M E M O R A N D U M

TO: For the Record 
FROM: A. Peter Barranco, Jr., P.E., Dam Safety Engineer
DATE: October 25, 1989
SUBJECT: Weston Upper Dam - Weston

Plan
1" = 20'

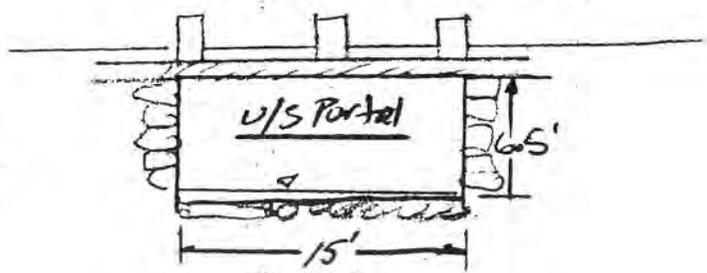
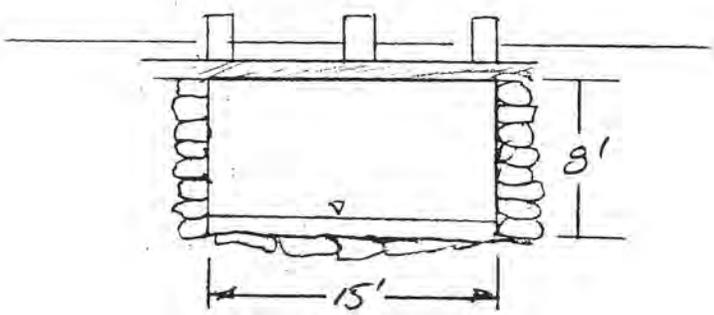
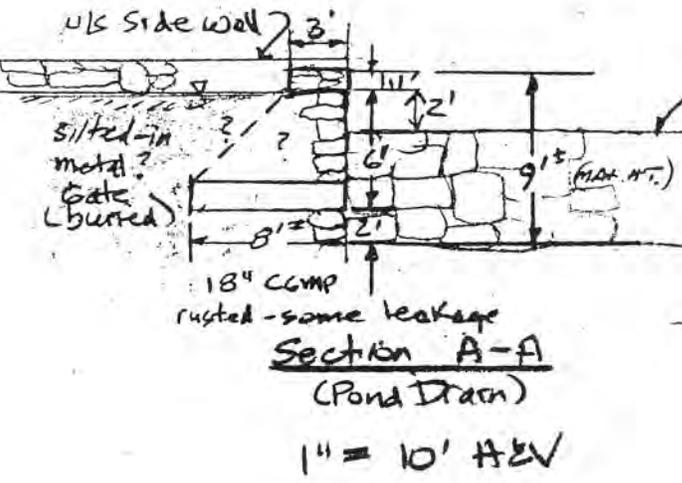
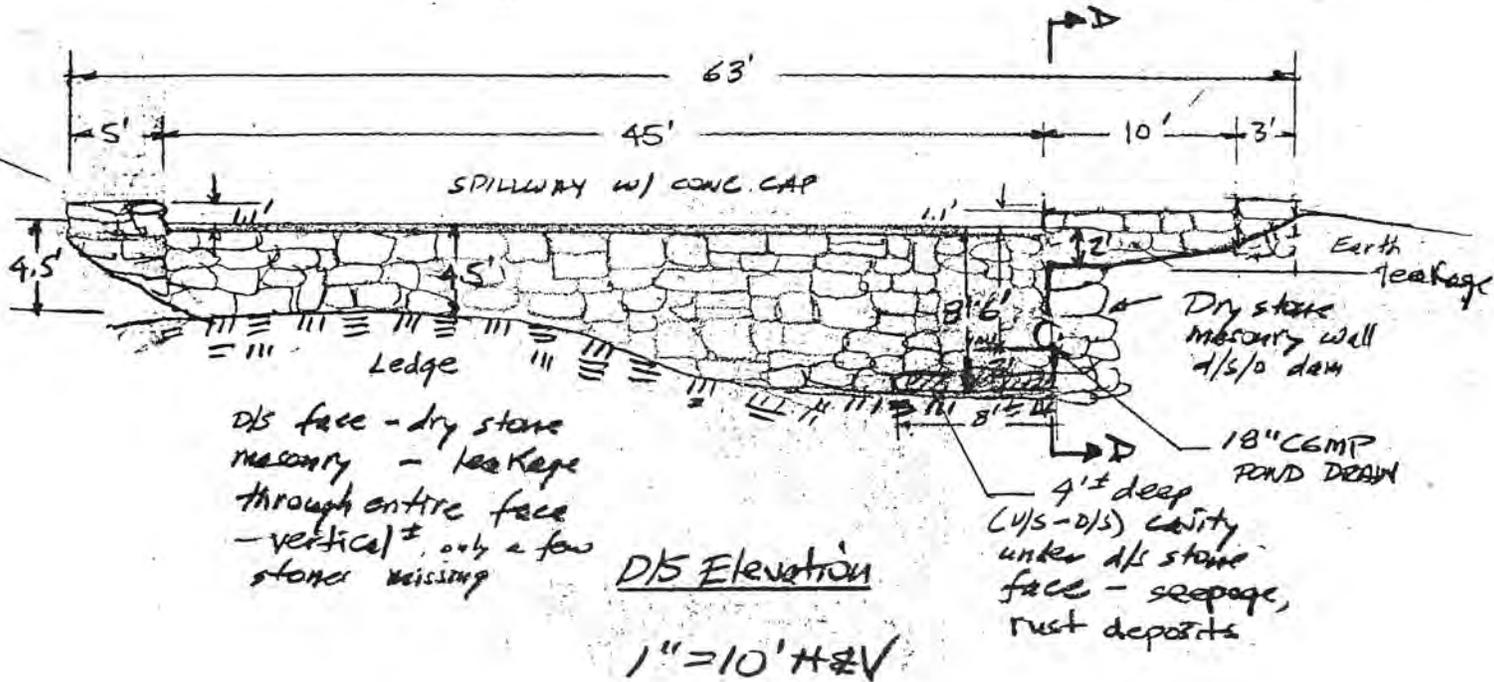
Alignment of both
wells is approx.

Upper Pond
 (silted in)
 $S.A. = 0.1 A$ (est.)
 Max height = 9'
 Length = 63'
Storage (est.)
 $NWL = 0.35 AF$
 (all sediments)
 $Ty \uparrow dam = 0.45 AF$
 (all but 0.1 AF
 sediment)

- D/S Channel**
- Lower Dam
 - Private bridge
 - No buildings subject to flooding by a failure of the dam from dam to West River.
 - Failure not likely to affect lower dam or bridge. Damage likely only from release of sediments.
